**Re: KIA's Technical Review of TMAC Resources Inc. Amendment
Application No. 1 of Project Certificate No.003 and Water Licence 2AM-
DOH1323 for the Doris North Project.**

Technical Review Comments for Amendment to Project Certificate 003 and Water Licence 2AM-DOH1323 for Doris North Mine Site.

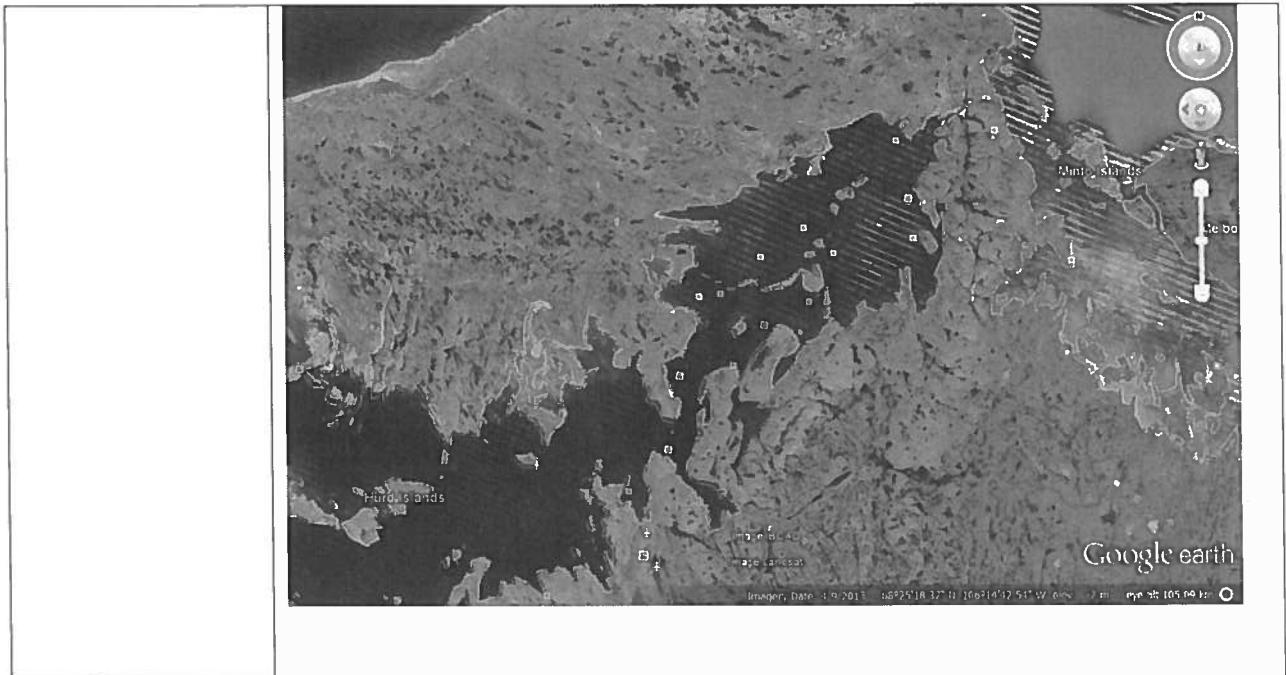
Importance of Issue to Impact Assessment (High, Medium, or Low):	Medium Risk
Detailed Technical Comment:	<p>Section 4.5.2.2 – “Nitrate” of the Environmental Effects report states...”by having the diffuser at 40 m depth, below the upper sun lit portion of the water column, nitrate in the TIA effluent and groundwater will not be readily available to phytoplankton, which will be photo-synthetically active in the upper water layers”. However, according to Section 4.3.3 (Basin Circulation) of the report, deeper water flowed into Roberts Bay from Melville Sound, and the top layer flowed seaward for roughly 70% of the measurement period. Figure 4.3-3 also shows deeper water in Roberts Bay circulating into the upper layer.</p> <p>The movement of water between deep and surface layers and how this affects surface water concentrations of nitrate and other COPC is not clear. The proponent has not modeled a mixing zone, or the resultant concentrations in the deep or surface waters. A water quality model is needed to determine the concentrations of nitrate and other parameters in the immediate mixing zone, and any mixing between the deep and surface layers.</p> <p>The proponent relies on exchange of Roberts Bay with the main ocean body to reduce COPC concentrations in Roberts Bay each year. Nitrate from Roberts Bay will eventually enter the wider circulation of the Arctic Ocean in the confined and shallower waters of the large embayment at the mouth of Roberts Bay that is confined by the large peninsula. TMAC has not provided any assessment of expected concentrations or the potential for nutrient enrichment there.</p>

Recommendation/ Request:	Provide a water quality model to determine the concentrations of nitrate and other parameters in the immediate mixing zone, and in deep and surface layers and confirm the prediction that nitrate will not be available in the surface waters of Roberts Bay. Please provide an assessment of nitrates in the ocean waters beyond Roberts Bay, from the Hurd Islands east to the head of the large bay, as shown in the Google maps image below.
